ON-SITE SEWAGE DISPOSAL SYSTEM HOWARD COUNTY HEALTH DEPARTMENT BUREAU OF ENVIRONMENTAL HEALTH

SUBDIVISION: Daisy Hill Estates LOT NUMBER: Parcel A

ADDRESS: 15734 Union Chapel Road PROPERTY OWNER: Jay & Lisa Santos

SEWAGE DISPOSAL SYSTEM

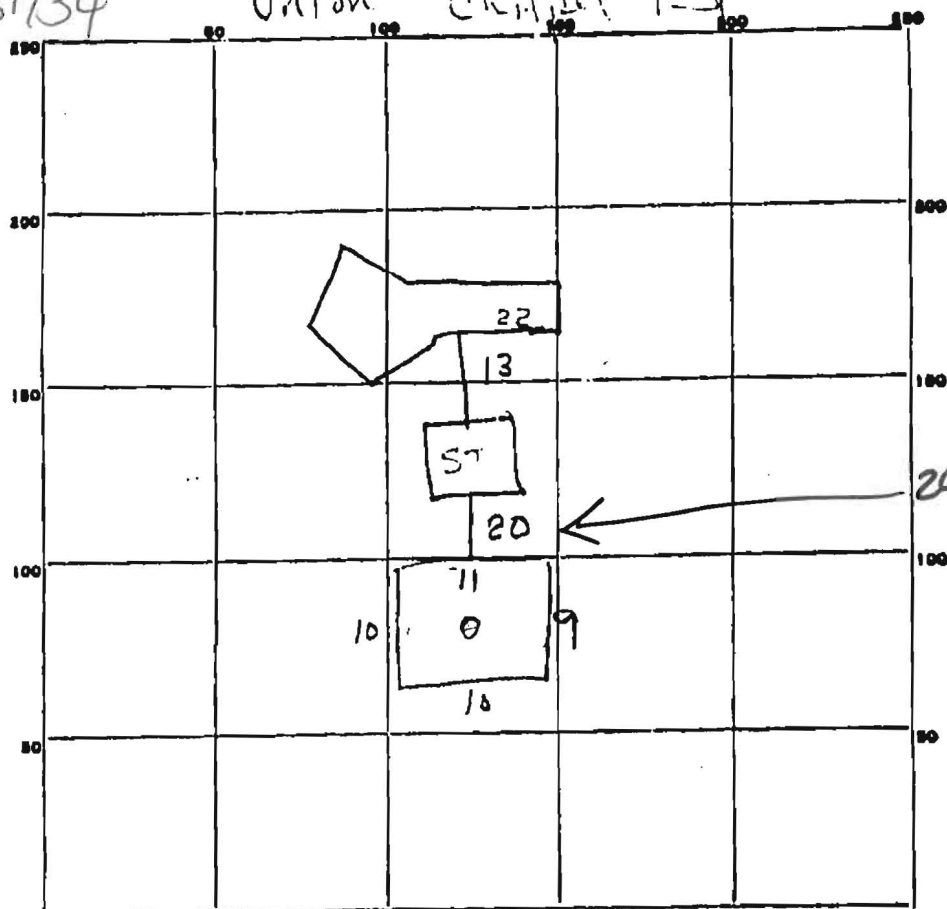
REMARKS Aug 3 1926 - System requires 80 addition sq ft
 Absorbative Area - remove plastic pipe from ST
 to DW - replace with cast iron AS called for
 in spec's - Add 12' trench 11' deep w no less
 than 8' of stone (AS per OWM) hal Benson
 8-3-26 - spoke w contractor on phone (Add 5' width buffer; trench, cast
 iron pipe from ST to DW)

Plastic Pipe replaced with c/d iron from ST-DW 17' of
12' trench added arched for higher elevation on Pipe from
DW to trench @ 3 ft
System Approved R Biggs
5 AUG 76

110
130
310
System located
AS per
diagram
